Project Our Town Hall

Drg Title Landscape General Arrangement

OTH-PLA-EE-ES-DWG-L-1000

C02

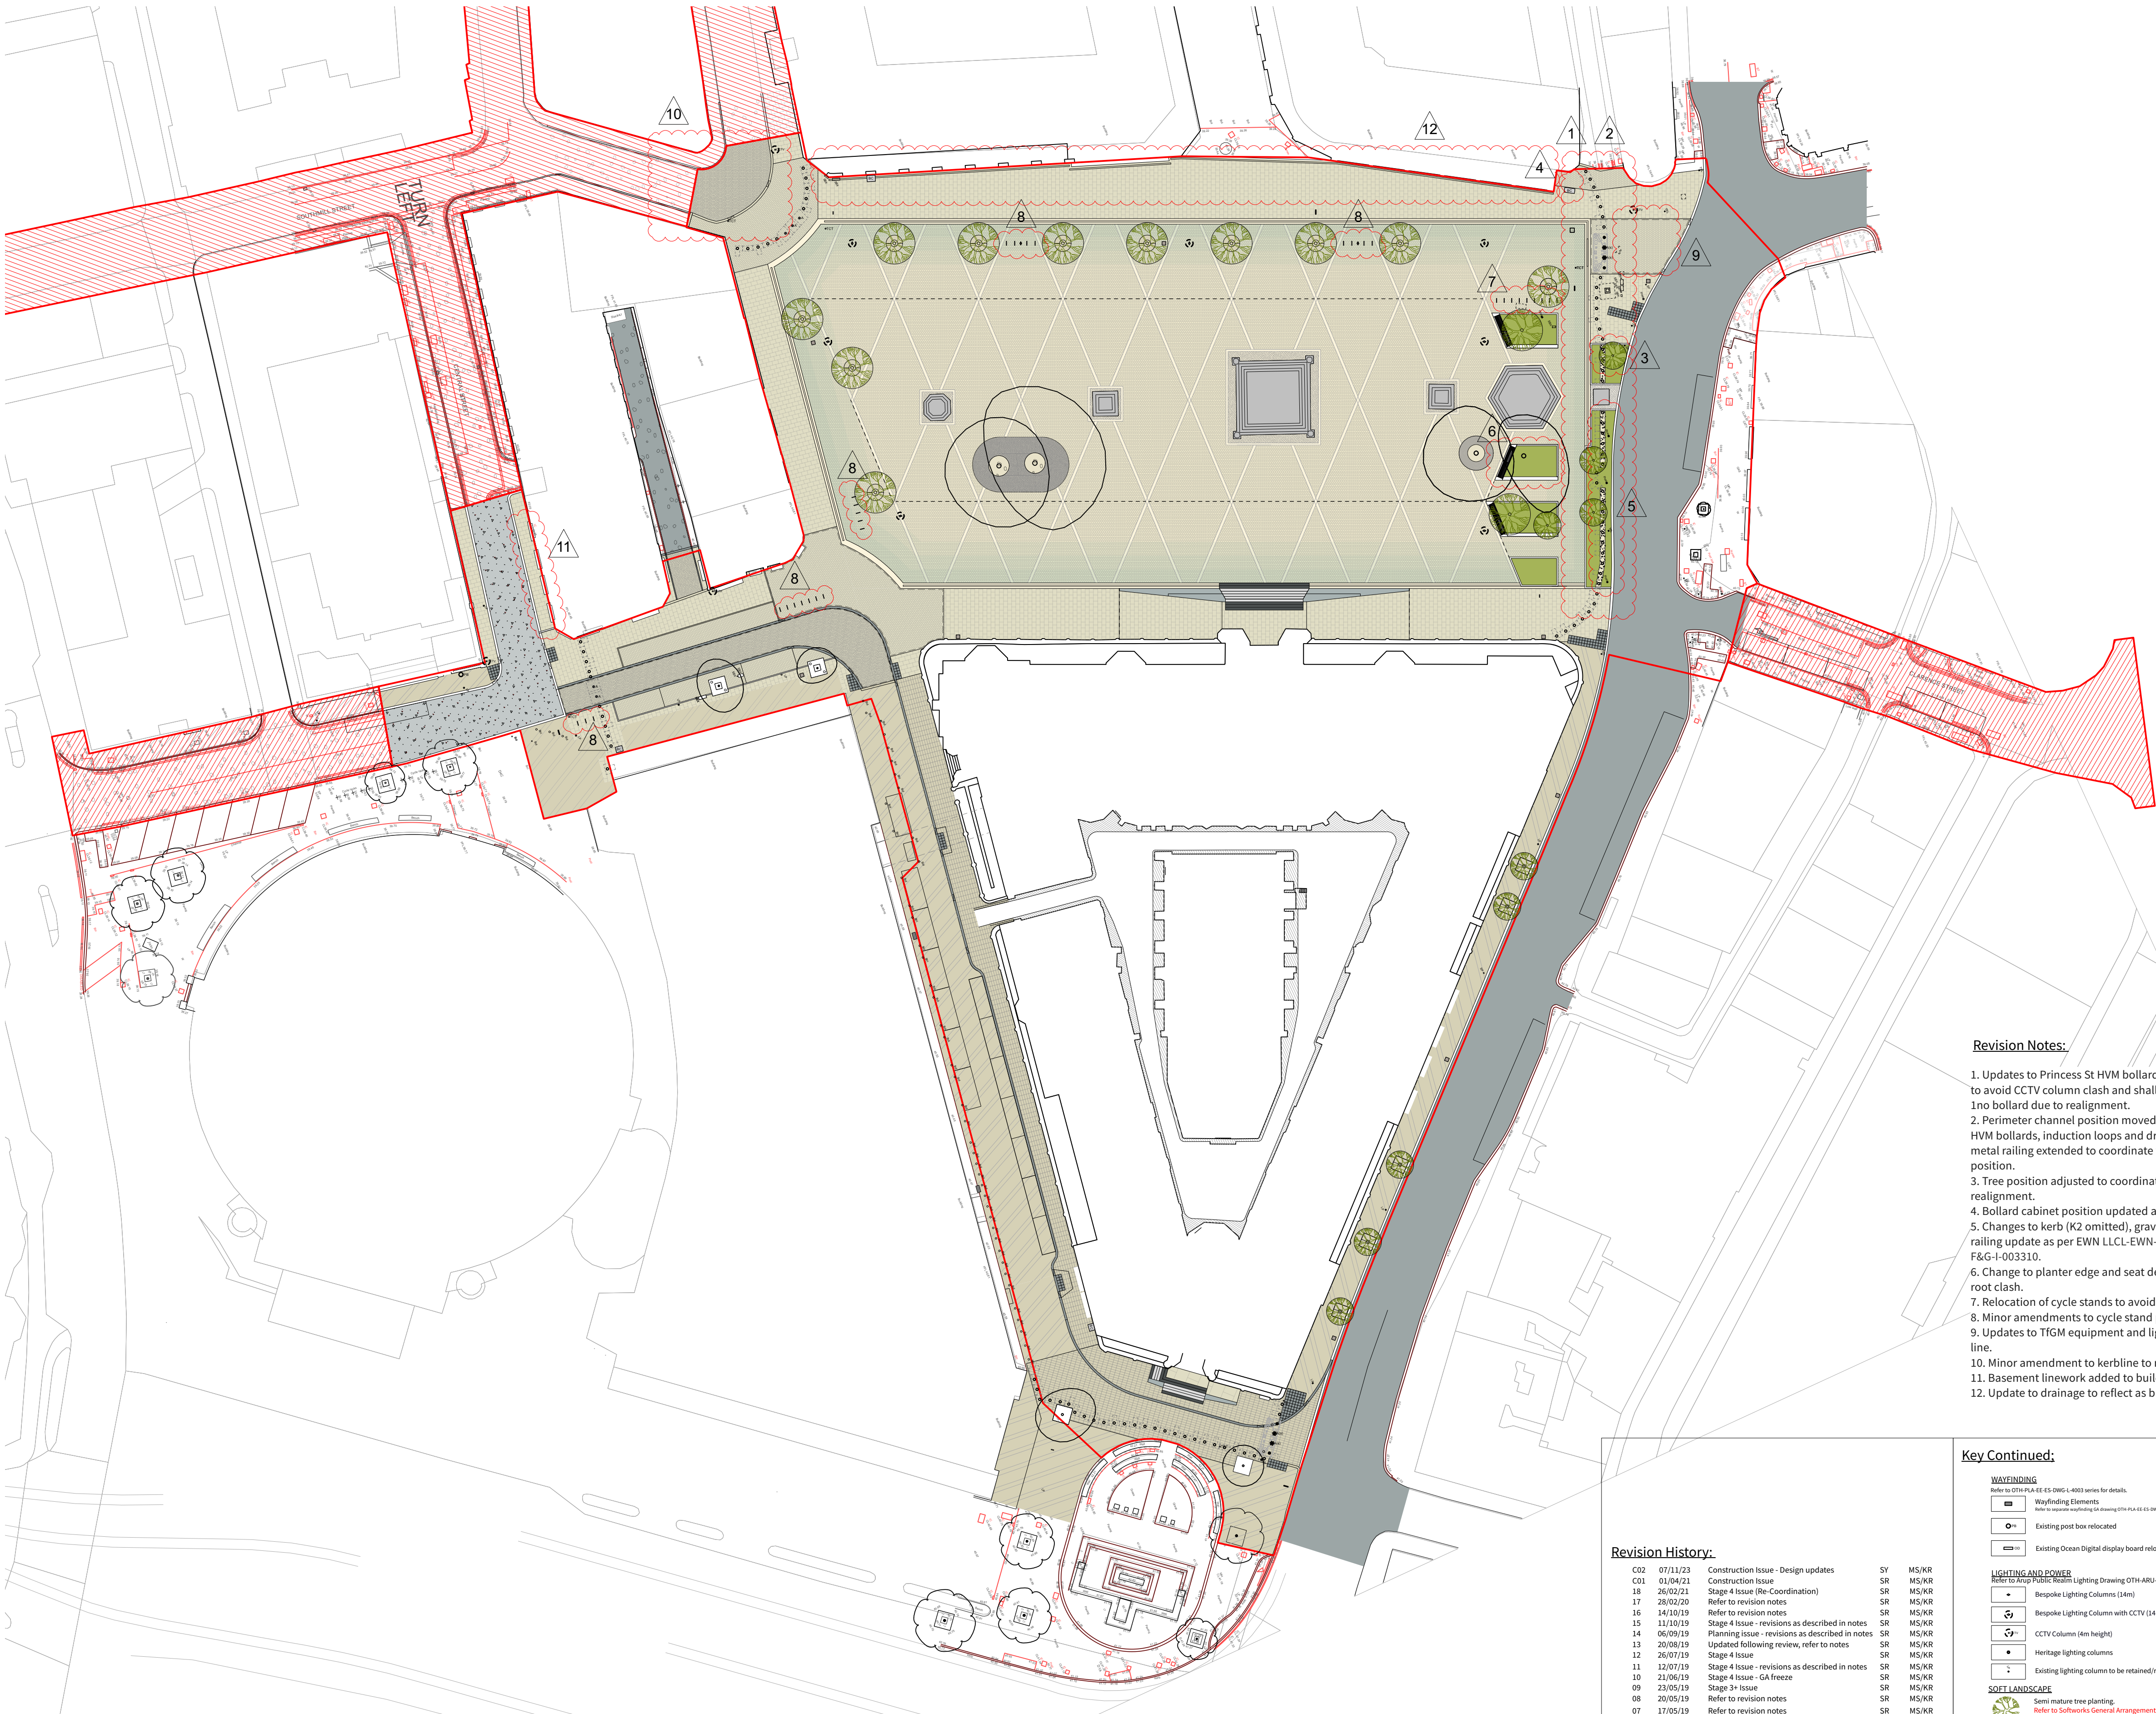
1. Updates to Princess St HVM bollard line - positions adjusted to avoid CCTV column clash and shallow services. Omission of 1no bollard due to realignment.

2. Perimeter channel position moved as part of coordination of HVM bollards, induction loops and drainage. Planters and metal railing extended to coordinate with new channel position.

3. Tree position adjusted to coordinate with bollard realignment.
4. Bollard cabinet position updated as agreed with LPA.
5. Changes to kerb (K2 omitted), gravel margin added and railing update as per EWN LLCL-EWN-001929 and Instruction F&G-I-003310.

6. Change to planter edge and seat detail to avoid existing tree root clash.
7. Relocation of cycle stands to avoid service cover clash.
8. Minor amendments to cycle stand positions / spacing.

9. Updates to TfGM equipment and lighting etc around HVM line.
10. Minor amendment to kerbline to reflect as built position.
11. Basement linework added to building edge on Central St.

12. Update to drainage to reflect as built.
